<u>PROJECT ADDRESS</u>	9603 SE 61ST PL MERCER ISLAND, WA 98040
<u>PROJECT NUMBER</u>	TBD
<u>ASSESSOR'S PARCEL #</u>	4260000020
<u>LEGAL DESCRIPTION</u>	LOT 2 OF LELAND ADDITION, AS PER PLAT RECORDED IN VOLUME 82 OF PLAT, PAGE 19, RECORDS OF KING COUNTY AUDITOR; SITUATE IN THE CITY OF MERCER ISLAND, COUNTY OF KING, STATE OF WASHINGTON.
<u>PROJECT DESCRIPTION</u>	SCOPE INCLUDES A MAIN FLOOR ADDITION (173.53 SF) AND UPPER LEVEL ADDITIONS (493.71 SF) TO EXISTING SINGLE-FAMILY HOME, INCLUDING INTERIOR ALTERATIONS PER PLAN. IN ADDITION, NEW 198 SF DETACHED MODULAR SHED TO BE ADDED PER PLAN.
<u>ZONE</u>	R-15
<u>BUILDING TYPE</u>	SINGLE FAMILY RESIDENCE

During the course of construction, extensive framing rot was encountered and a few alterations were made as a result of the need to re-frame those areas. We are proposing to alter the STAR atrium roof framing from a Gable to shed as part of the rebuild. The new roof form will be lower than the proposed building height as previously permitted and below the MAX allowable building height. Additional changes that occurred as a result of demo discovery and rot repair are using closed cell insulation throughout the roof cavity, new siding scope

1 EXTERIOR DEMOLITION ELEVATION - NORTHWEST
1/4" = 1'-0"2 EXTERIOR DEMOLITION ELEVATION - WEST
1/4" = 1'-0"

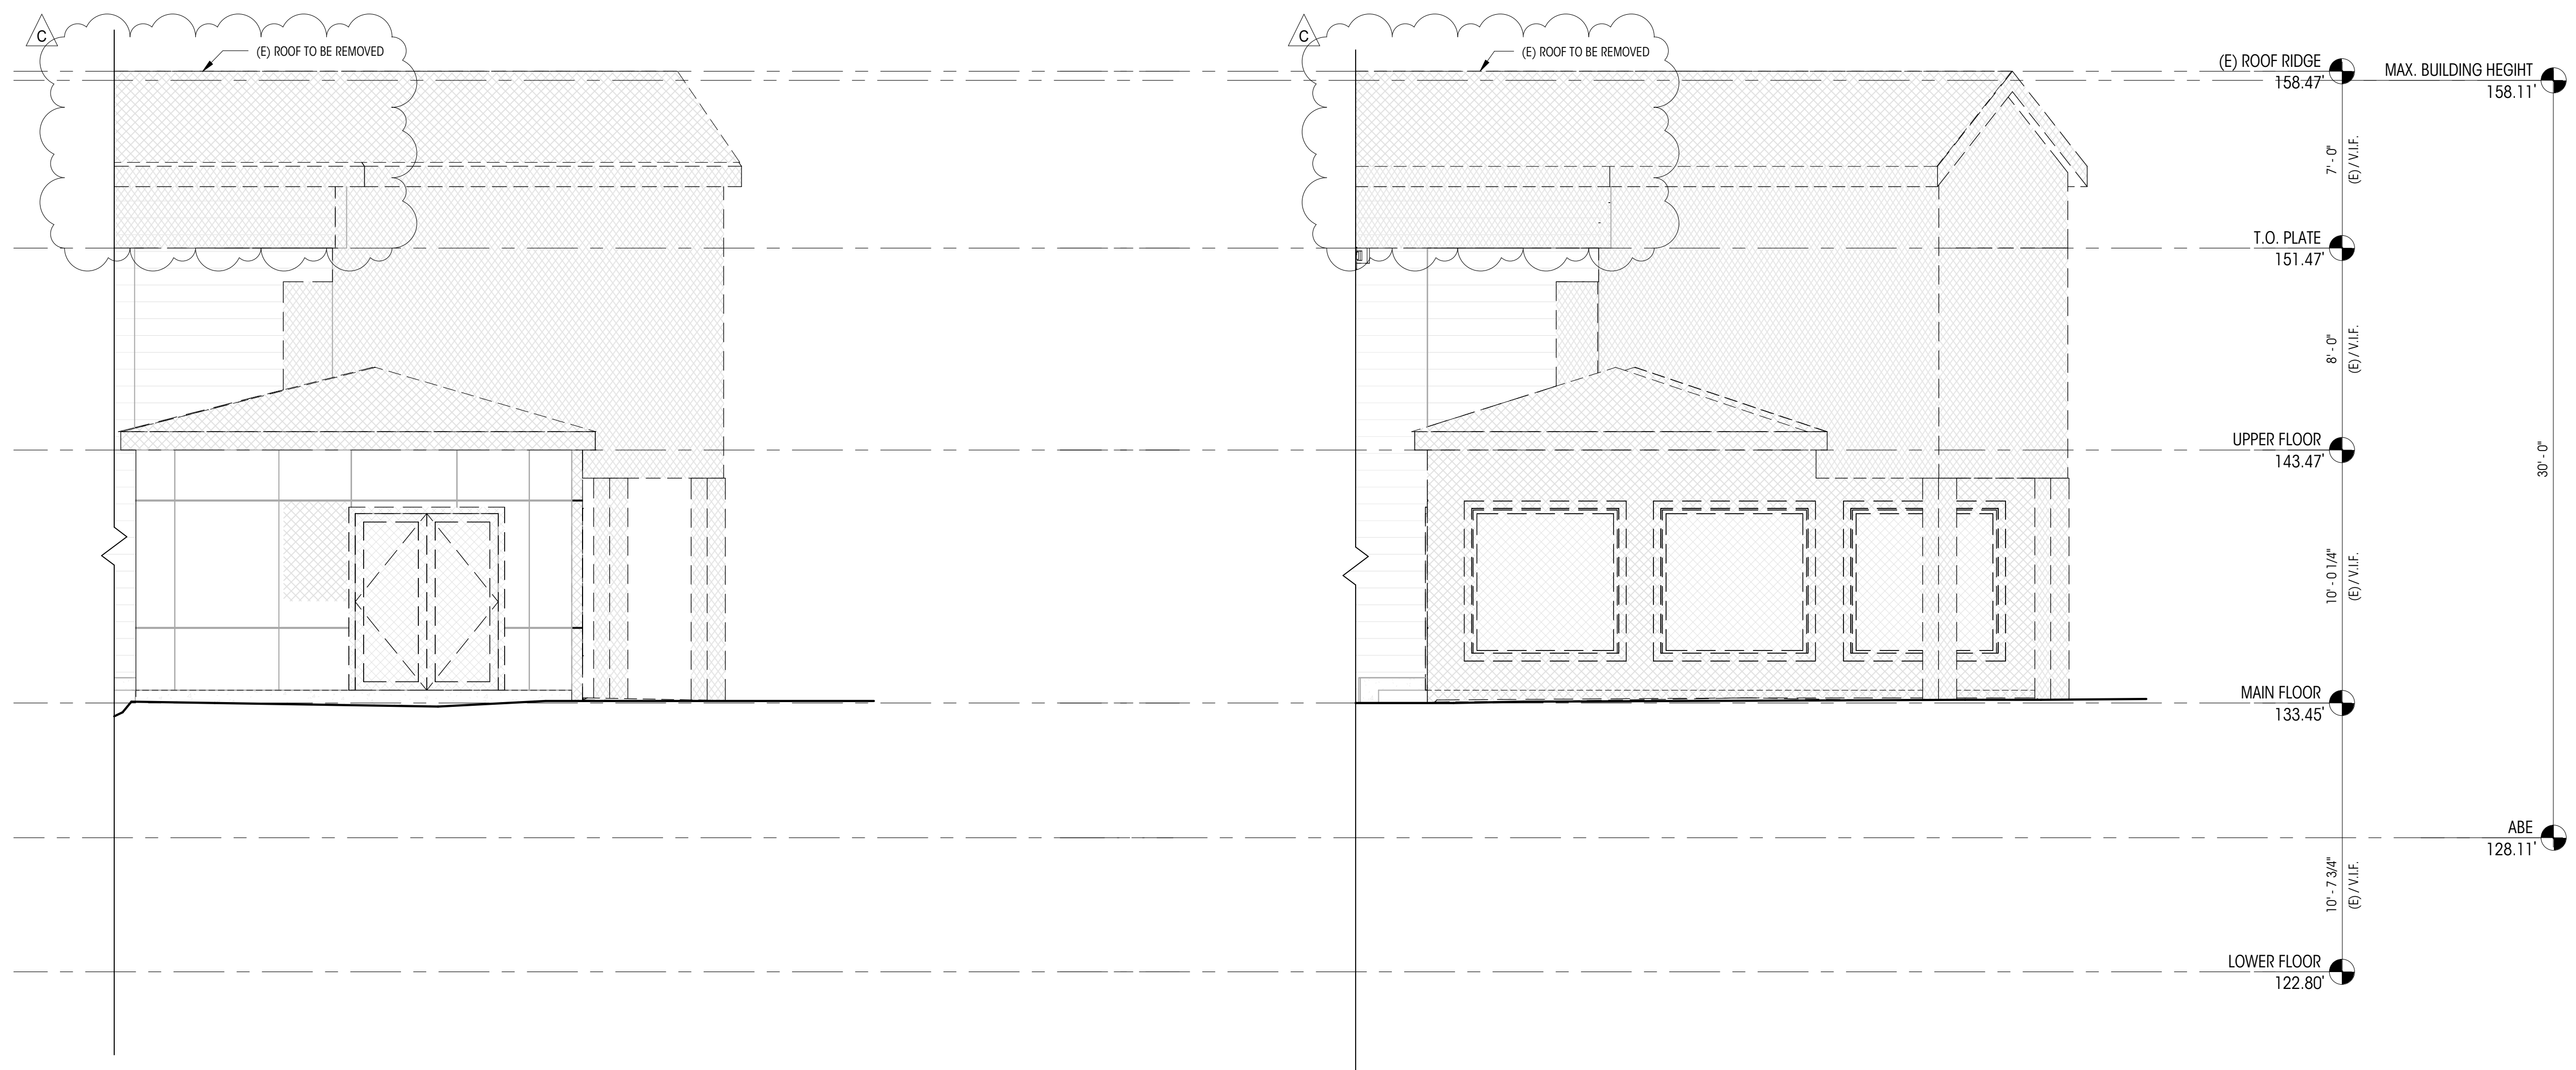
- EXISTING ROOF TO BE REMOVED DUE TO DAMAGE FROM ROOF ROT. NEW ROOF TO BE INSTALLED BELOW THE MAX. BUILDING HEIGHT, WITH NO PROPOSED CHANGE TO LOT COVERAGE OR HARDSCAPE.
- WALL ROT; EXISTING SIDING, SUBSTRATE AND FRAMING TO BE REMOVED AND REPLACED IN PLACE. GC TO VERIFY EXTENTS OF DAMAGE.

1 EXTERIOR DEMOLITION ELEVATION - SOUTH

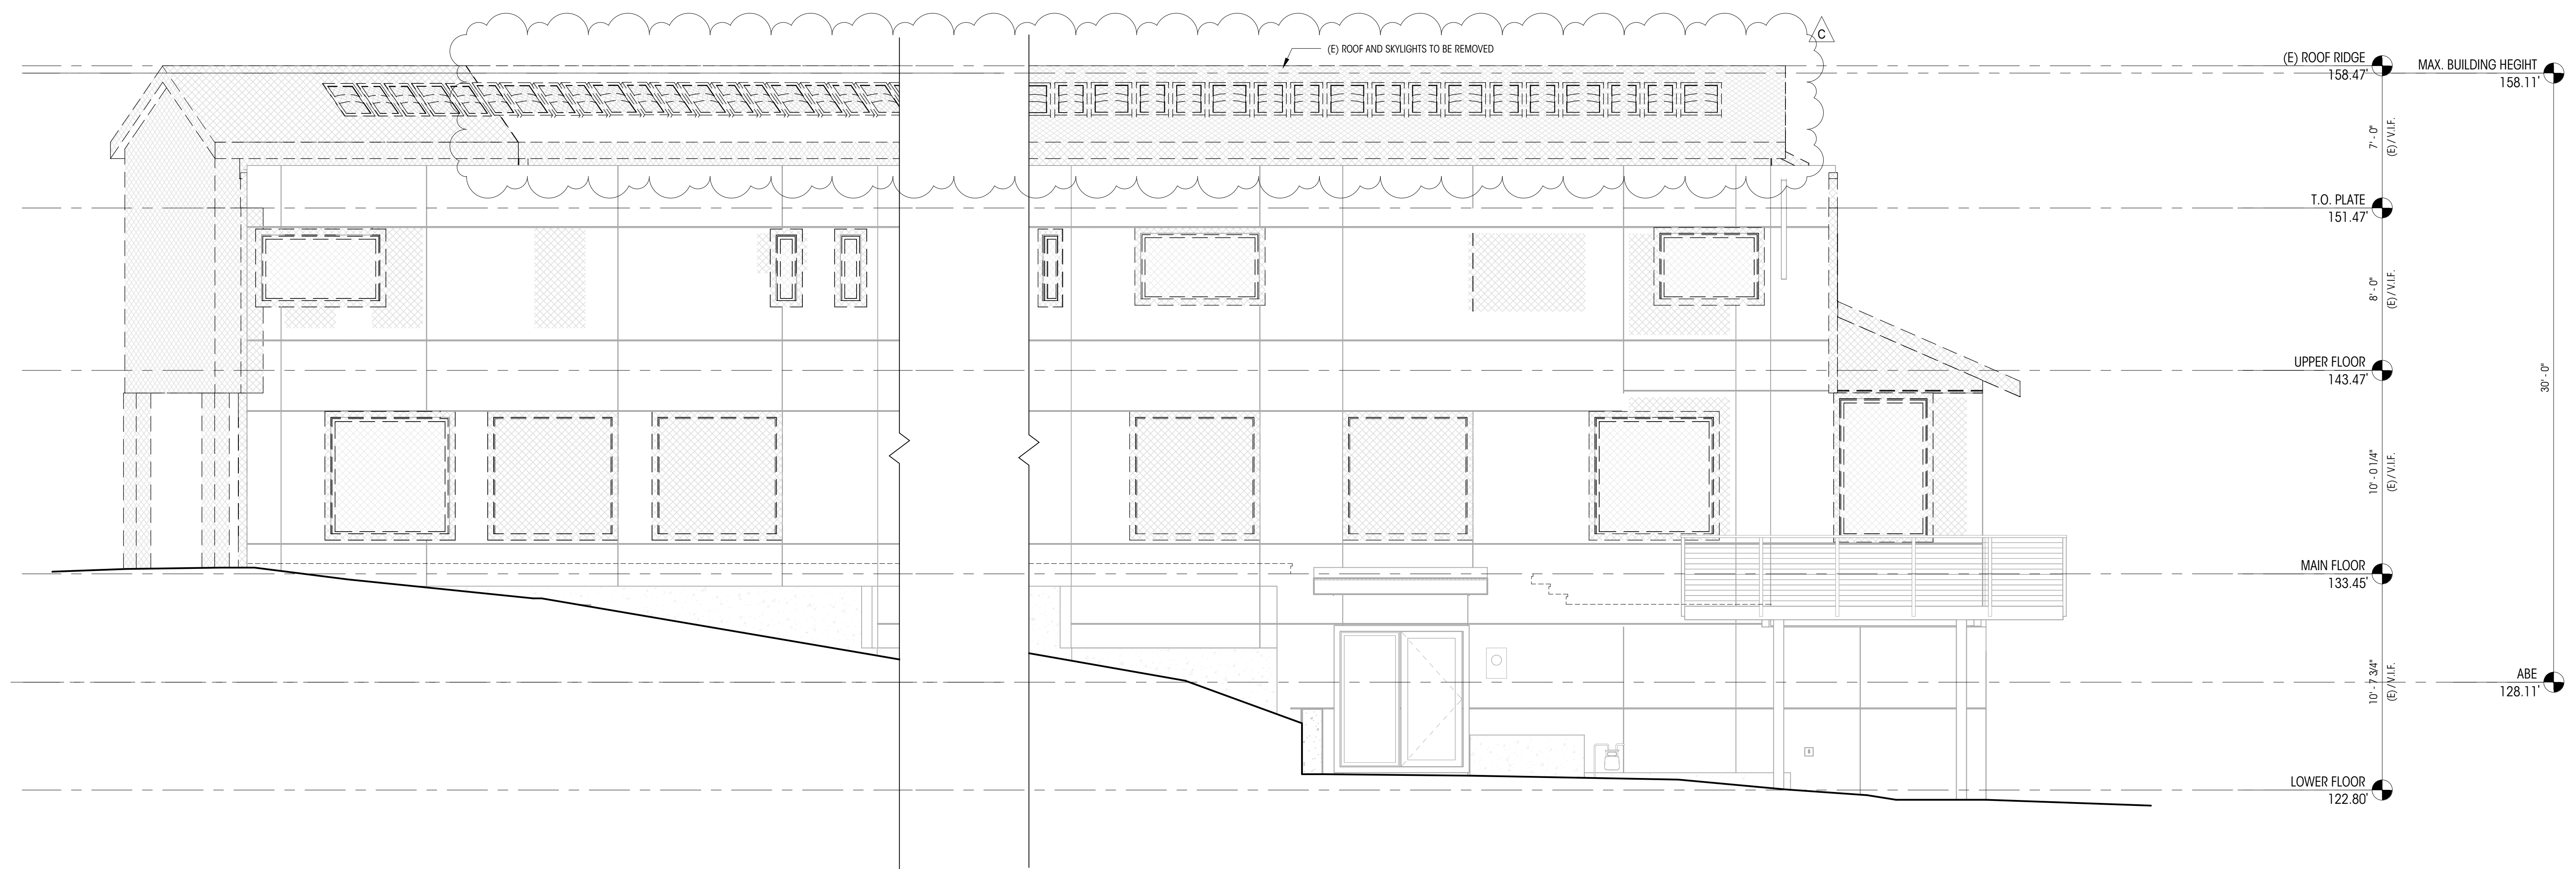
- EXISTING ROOF TO BE REMOVED DUE TO DAMAGE FROM ROOF ROT. NEW ROOF TO BE INSTALLED BELOW THE MAX. BUILDING HEIGHT, WITH NO PROPOSED CHANGE TO LOT COVERAGE OR HARDSCAPE.
- WALL ROT; EXISTING SIDING, SUBSTRATE AND FRAMING TO BE REMOVED AND REPLACED IN PLACE. GC TO VERIFY EXTENTS OF DAMAGE.

A301

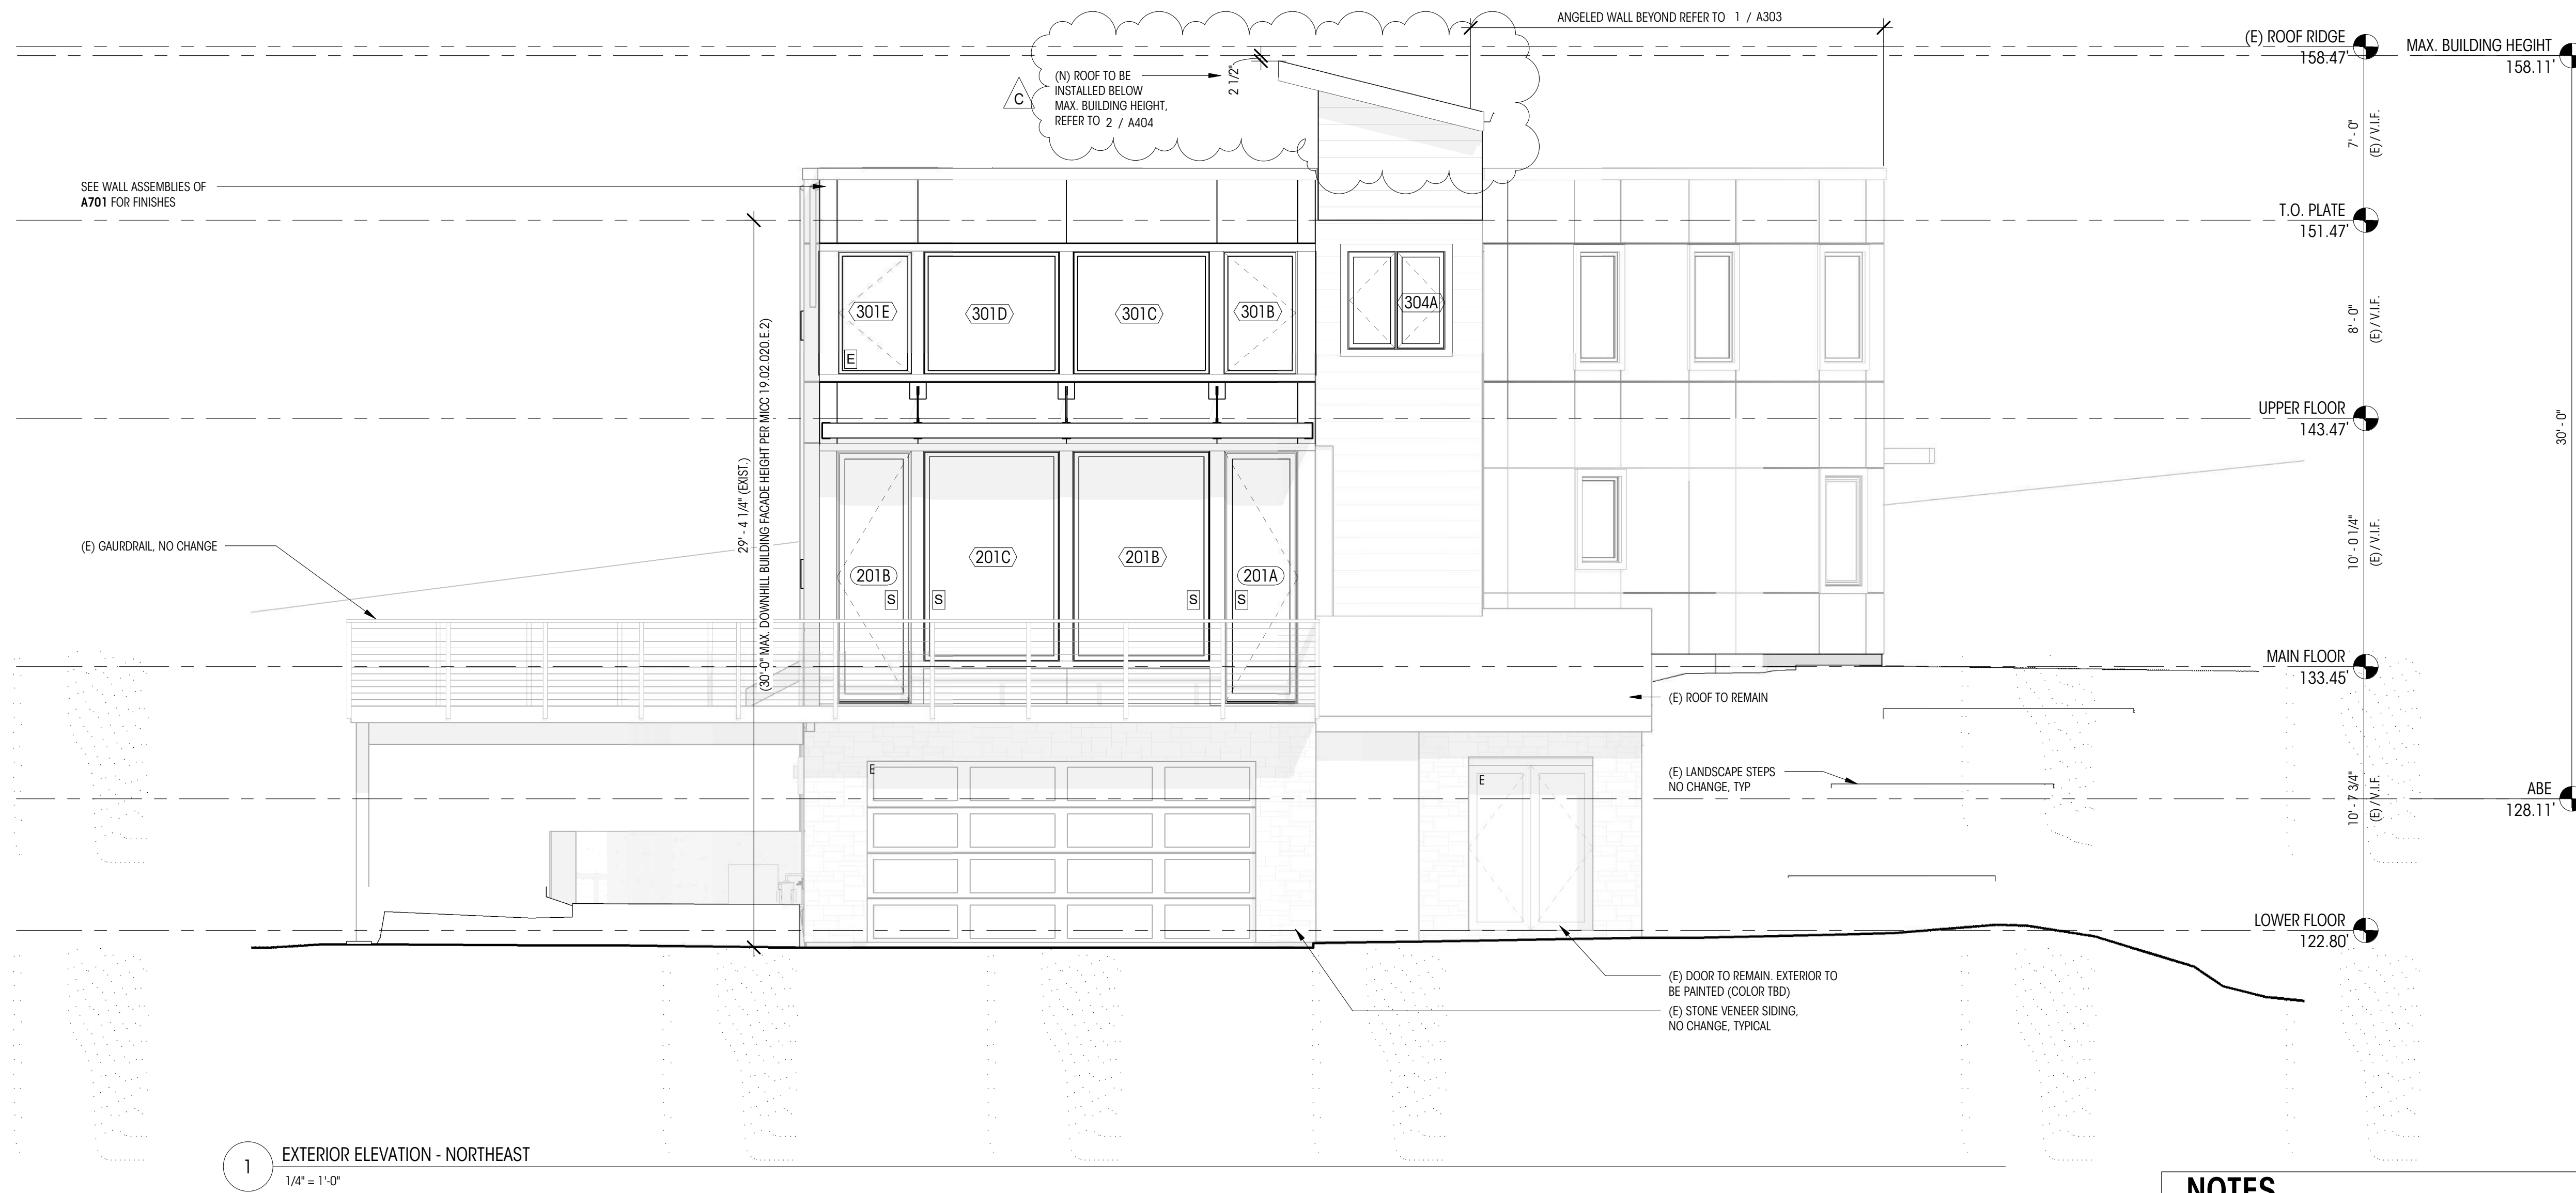
- EXISTING ROOF TO BE REMOVED DUE TO DAMAGE FROM ROOF ROT. NEW ROOF TO BE INSTALLED BELOW THE MAX. BUILDING HEIGHT, WITH NO PROPOSED CHANGE TO LOT COVERAGE OR HARDSCAPE

- WALL ROT, EXISTING SIDING, SUBSTRATE AND FRAMING TO BE REMOVED AND REPLACED IN PLACE. GC TO VERIFY EXTENTS OF DAMAGE.

1 EXTERIOR ELEVATION - NORTH
1/4" = 1'-0"

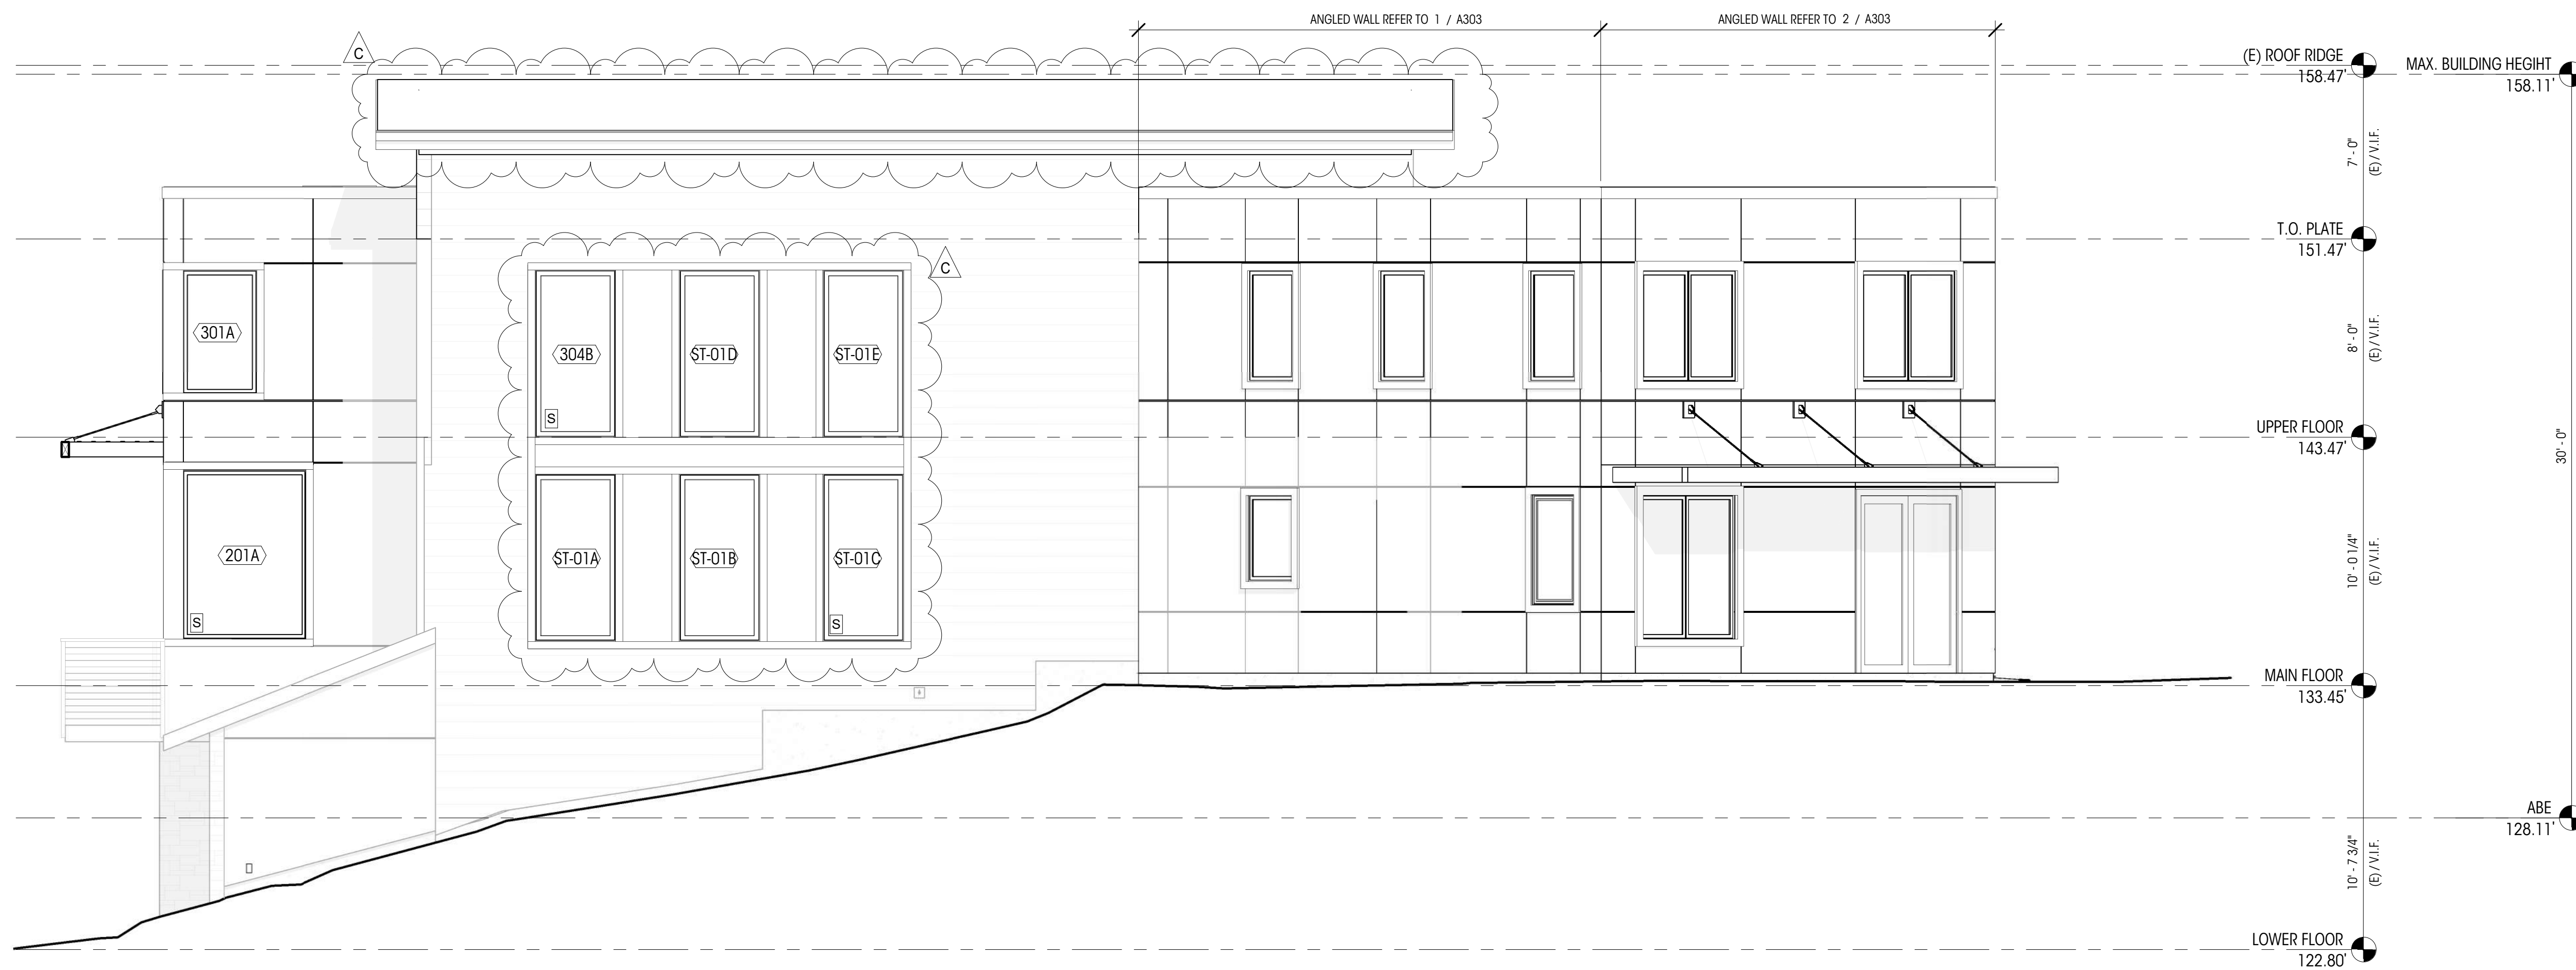
- EXISTING ROOF TO BE REMOVED DUE TO DAMAGE FROM ROOF ROT. NEW ROOF TO BE INSTALLED BELOW THE MAX. BUILDING HEIGHT, WITH NO PROPOSED CHANGE TO LOT COVERAGE OR HARDSCAPE.
- WINDOWS ST-01A-E AT (E) STAIR ST-01 AND 304B AT OFFICE ADDED.
